Economic Commission for Europe**Inland Transport Committee****Working Party on the Transport of Perishable Foodstuffs****Seventy-seventh session**

ATP Handbook**Amendment to paragraph 7.3.6 of Annex 1, Appendix 2 of the ATP Handbook: Treatment of specific application cases using the multi-temperature equipment dimensioning tool****Transmitted by the Government of France****Introduction**

Example: case of a “J” configuration

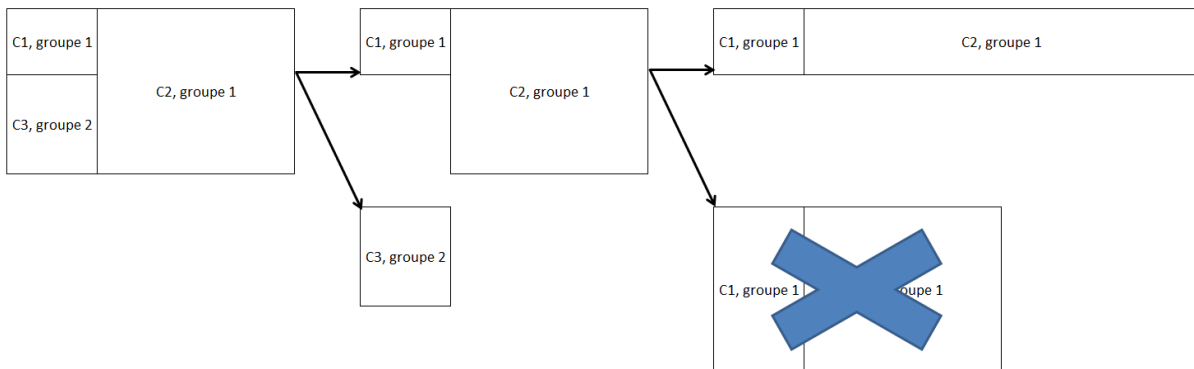
- The dimensioning is checked for the most unfavourable case

- The supporting document presents all configurations

The compartments are numbered starting from the front left compartment of the equipment. In the above example, according to this rule, the compartment numbers differ depending on whether the longitudinal bulkhead is connected to the front or the rear of the equipment. However, the dimensioning method does not change.
